BEAVER VALLEY POWER STATION, UNIT NO. 1

AMENDMENT TO FACILITY OPERATING LICENSE

Amendment No. 46
License No. DPR-66

RELATED TO AMENDMENT NO. 46 TO FACILITY OPERATING LICENSE NO. DPR-66

**Figure 6.2-1
Offsite Organization (Partial)**

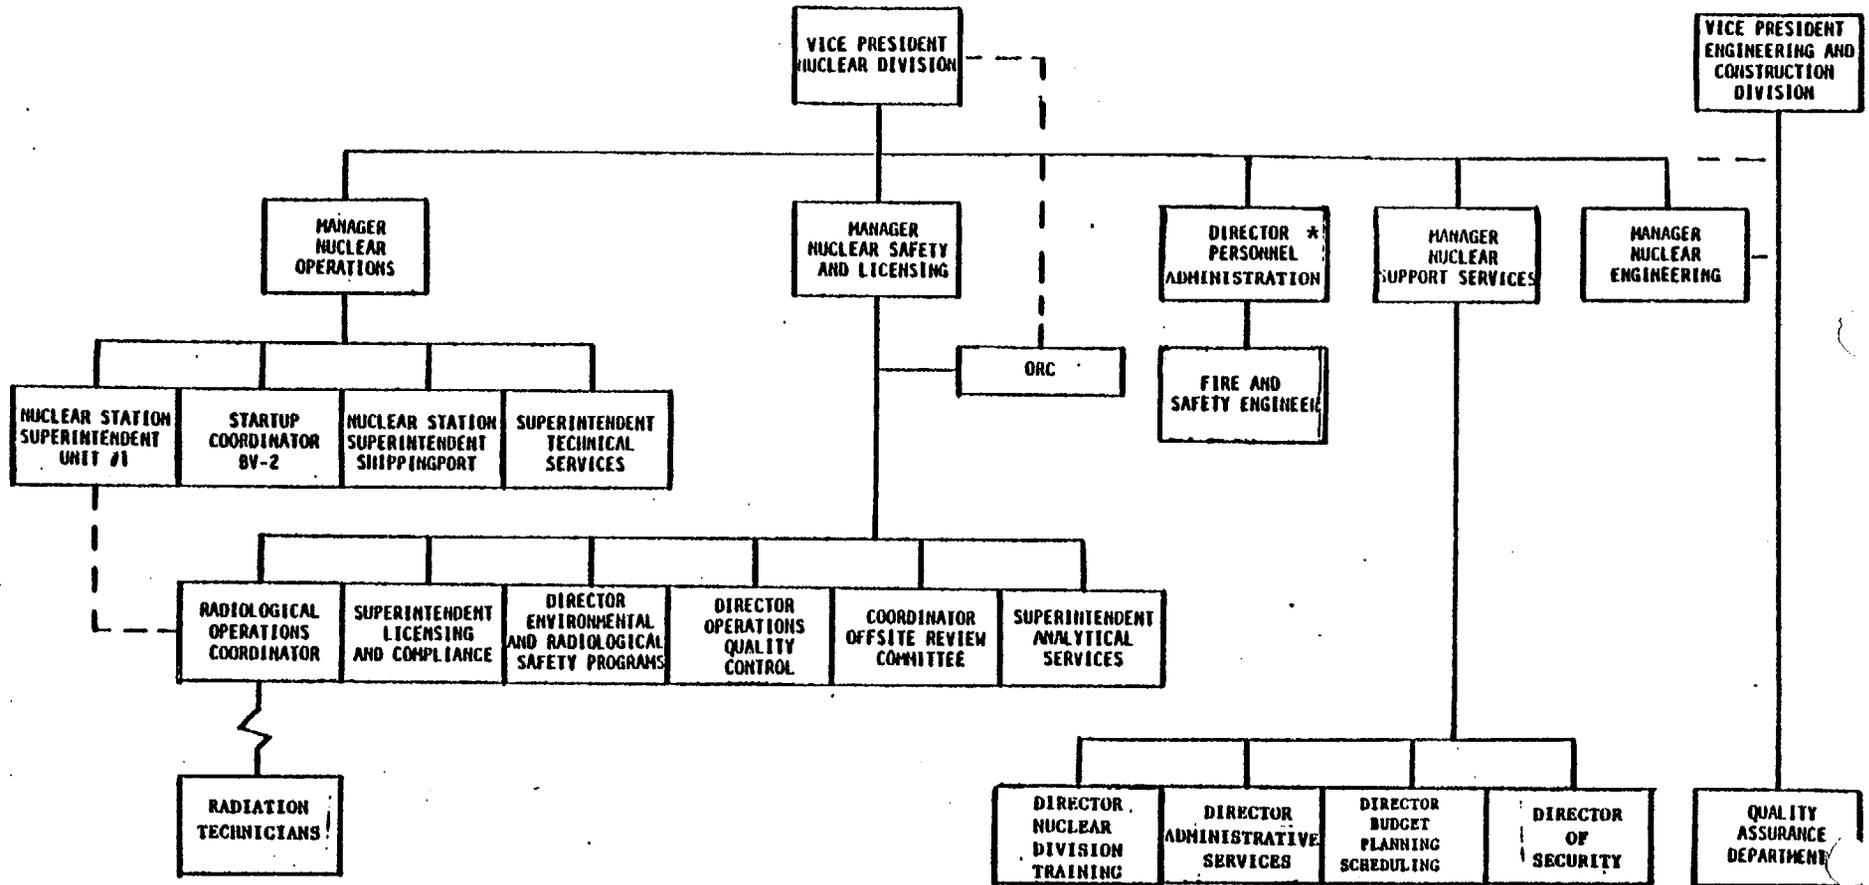
The licensee has proposed to modify its corporate organizational structure to consolidate its major nuclear power plant operation and support activities within a single new corporate division, the Nuclear Division, which is headed by a Vice President whose sole responsibility is for nuclear power related activities. It has also proposed to modify the Beaver Valley Unit 1 plant organizational structure.

The proposed offsite organization reporting to the Vice President - Nuclear Division includes a Manager - Nuclear Operations, Manager - Nuclear Safety and Licensing, Manager - Nuclear Support Services, and Manager - Nuclear Engineering.

The Beaver Valley Unit 1 Station Superintendent reports to the Manager - Nuclear Operations. A new position of Superintendent - Technical Services also reports directly to the Manager - Nuclear Operations. A number of the technical support functions that are currently assigned to the Station Superintendent are assigned to the Superintendent - Technical Services in the new organization. These include the shift technical advisors, refueling, chemistry and station engineering. The current position of Chief Nuclear Engineer has been eliminated from the proposed station organization and the Supervisor - Nuclear Station Operations reports directly to the Station Superintendent. The Instrument and Control function, which is under the Maintenance Supervisor in the current organization, has been set up under a separate Supervisor - Instrument and Control who reports directly to the Station Superintendent. The Supervisor - Maintenance retains the mechanical and electrical maintenance function but reports directly to the Station Superintendent rather than to the Chief Nuclear Engineer.

Other support functions that are under the Station Superintendent in the current organization, including radiation protection, fire protection, nuclear engineering, training, security and office and records are reorganized under the new offsite organization Managers of Nuclear Safety and Licensing, Nuclear Support Services and Nuclear Engineering and the Director, Personnel Administration.

On the basis of our evaluation as discussed above, we have concluded that the organizational changes should enhance the ability of the licensee to manage and safely operate the Beaver Valley Power Station Unit 1 and are acceptable.

Figure 5.1-1
Duquesne Light Company
Nuclear Division
Partial Organization Chart
Relative to Environmental Matters

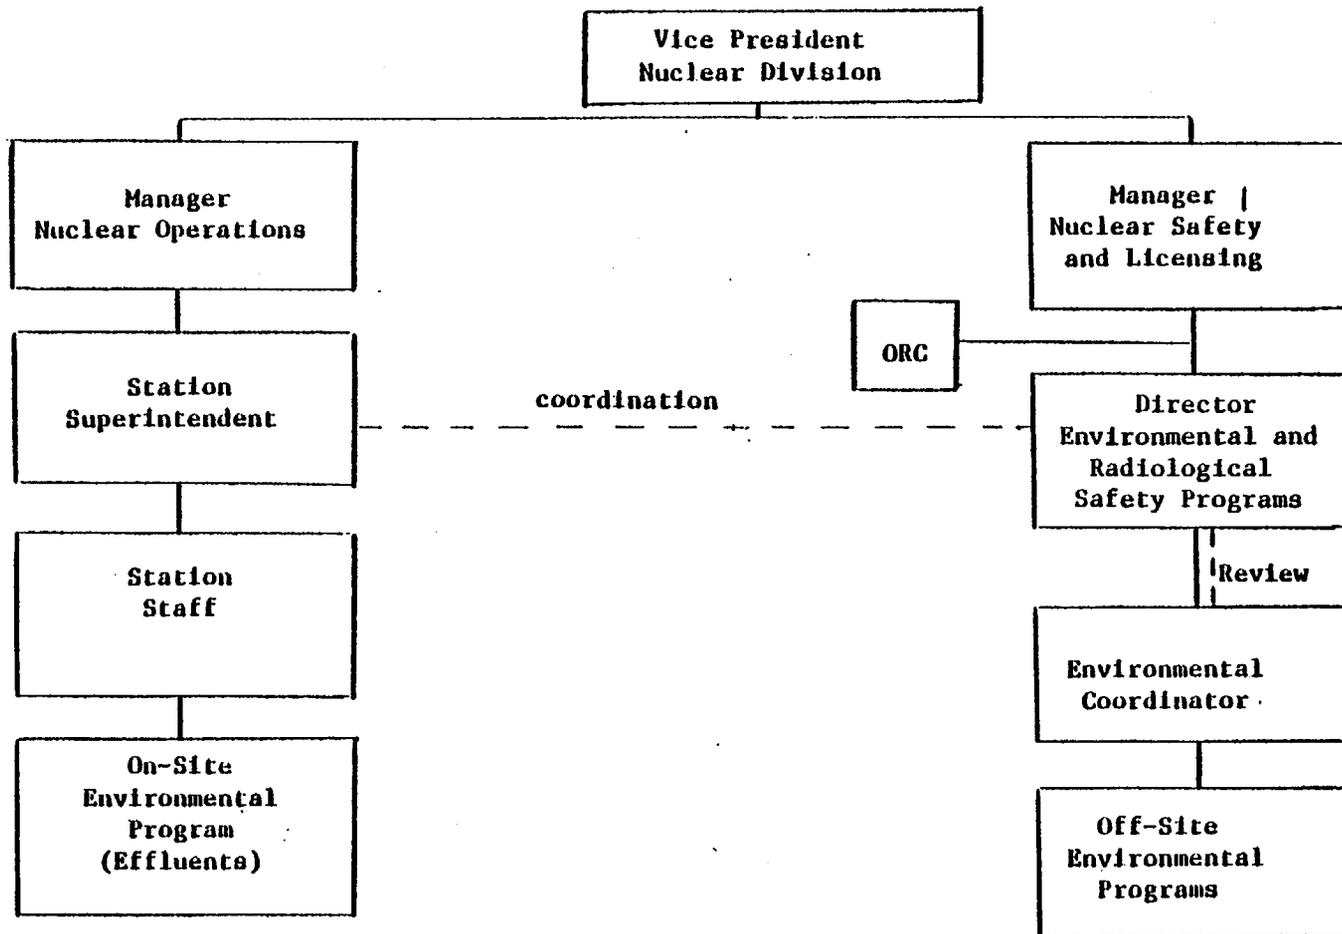
Figure 5.1-1 is a partial organization chart of the Nuclear Division which includes groups and individuals responsible for environmental protection, environmental monitoring and the implementation of the Environmental Technical Specifications following the issuance of an operating license for Beaver Valley Unit No. 1.
